Grand Teton National Park
Wyoming

COLTER BAY VISITOR SERVICES PLAN/ ENVIRONMENTAL ASSESSMENT FINDING OF NO SIGNIFICANT IMPACT

VISITOR SERVICES PLAN / ENVIRONMENTAL ASSESSMENT GRAND TETON NATIONAL PARK

Colter Bay Visitor Services Plan
 Grand Teton National Park, Wyoming
 Revised January 2013

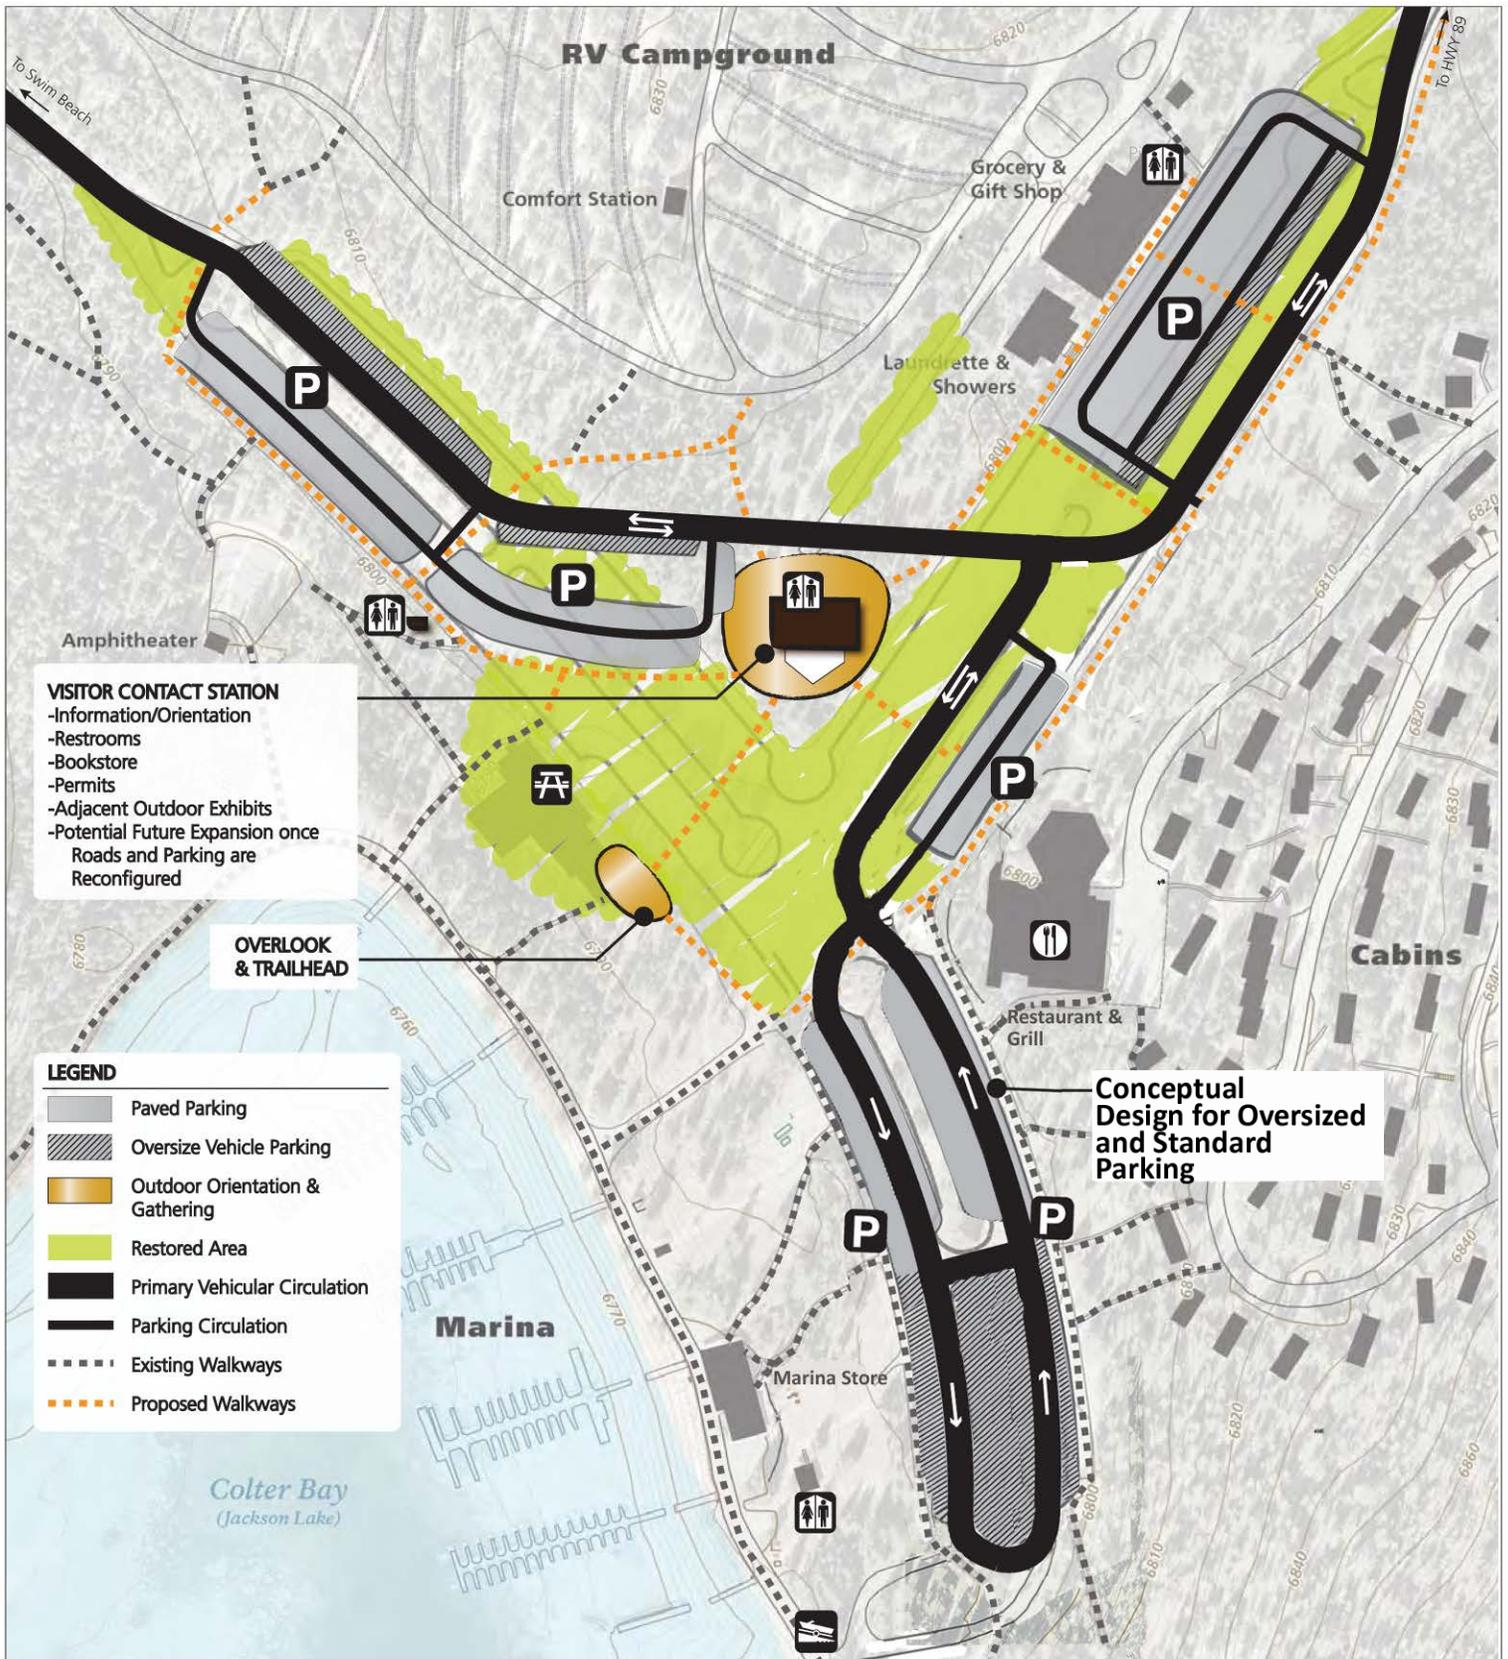
Comments on page 37 [of the Visitor Services Plan / Environmental Assessment] leaves me with the impression that Alternative B will result in fewer passenger vehicle parking spaces near the marina and trail head. My experience during the summer is that it is often difficult to find parking for passenger vehicles in this area. My recommendation is that there be no significant reduction of single vehicle parking in this portion of the development.

I... would suggest that you consider a roundabout rather than the dangerous T intersection that you have in your current plans for Alternative B.

Revise the preferred alternative design of the eastern half of the marina parking lot (half closest to the marina). Larger vehicles, such as recreational vehicles, should utilize pull through parking spaces versus parallel parking or pull-in parking. In addition, a wider turning radius should be added on each end of the marina parking area to enable larger vehicles to negotiate the corners. The marina parking lot design in Alternative C is more suitable for these larger vehicles.

At a minimum, the Y in the road should be moved farther south on the road to allow for the planned parking to be available for the restaurant.

Upon approval of this plan and when funding is secured, the National Park Service will begin the detailed architectural and engineering design phase of this planning effort. The National Park Service may make changes to specific parking areas and

the number of parking spaces provided in the selected alternative in order to meet the specific needs of various vehicle types and Colter Bay destinations (e.g. visitor contact station, general store, restaurant, and marina). The National Park Service will also take into consideration how each of the parking areas are currently used and will make minor modifications to the selected alternative site plan (see attached revised selected alternative site plan) as appropriate.
